**Engine Harness Changes**  
**D11J, D13J**  
**VAH, VHD, VN**

**FSB 284-056, Engine Harness Changes**

(April 2015)

W2100467

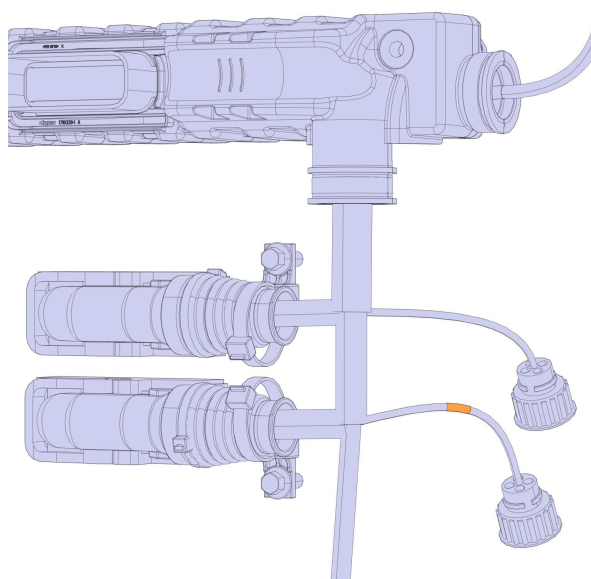
- D13 Engine Only: Yellow marking tape added to crankcase pressure sensor wire. Blue marking tape removed from oil pressure sensor wire.

W2100052

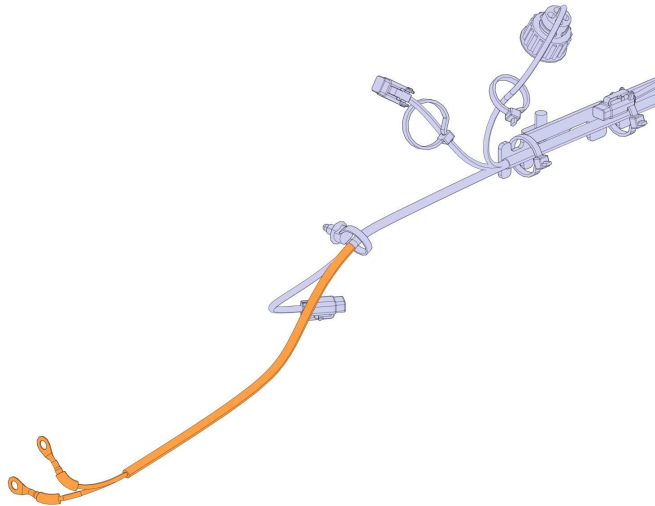
- The starter solenoid wires now come from the front. Previous starter wire routed around the cold side of engine around the rear.

W2100055

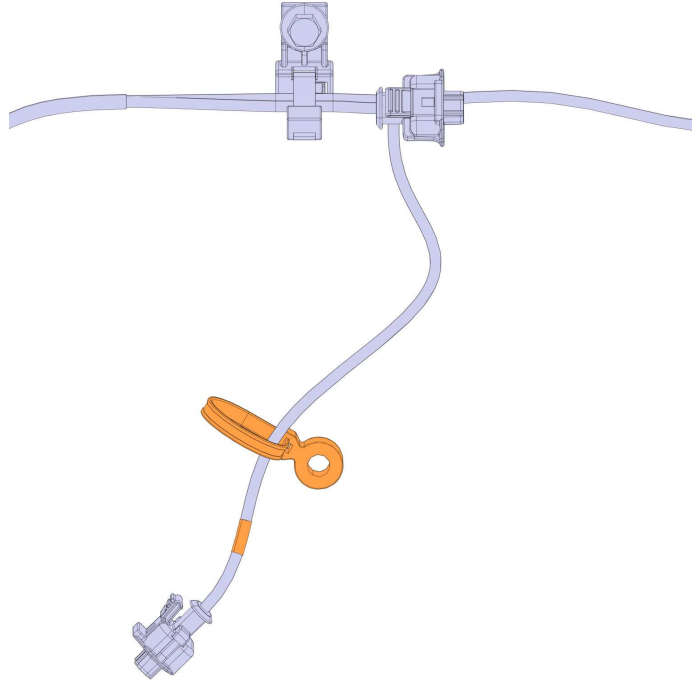
- D13 Engine Only: Crankshaft speed sensor has yellow marking tape on it so it is not confused with EGR valve sensor. Stud-mounted cable tie added.
